**From:** Kuntz, Robert  
**Sent:** Monday, September 08, 2014 3:10 PM  
**To:** RILEY, Jim (jhr@nei.org)  
**Cc:** Whaley, Sheena; Cook, Christopher  
**Subject:** NRC Comments on NEI white paper regarding warning time for LIP event  
**Attachments:** Warning Time for Extreme Precipitation Events (NWS Protocol) Rev2 9-8-14 with NRC comments.pdf

# Warning Time for Maximum Precipitation Events

Rev 1a, 8-14-14

# Attachment 1

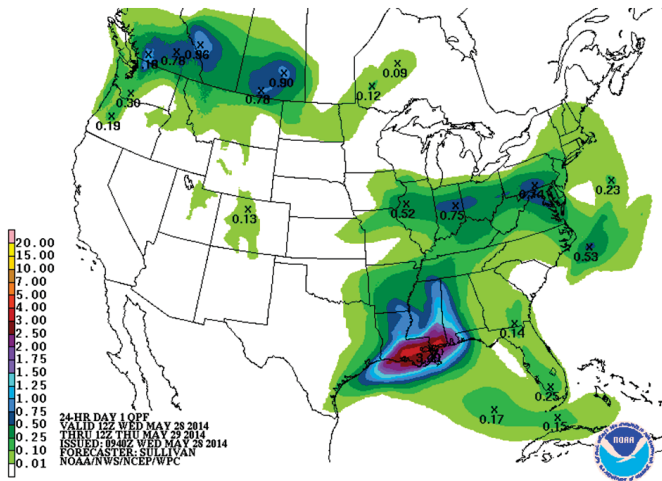
**Comment [NRC28]: Editorial/technical note:**  
The actual map image in Attachment 1 only shows information in the second form (precipitation amount by percentile). However, it does show the tool with tabs for the different types.
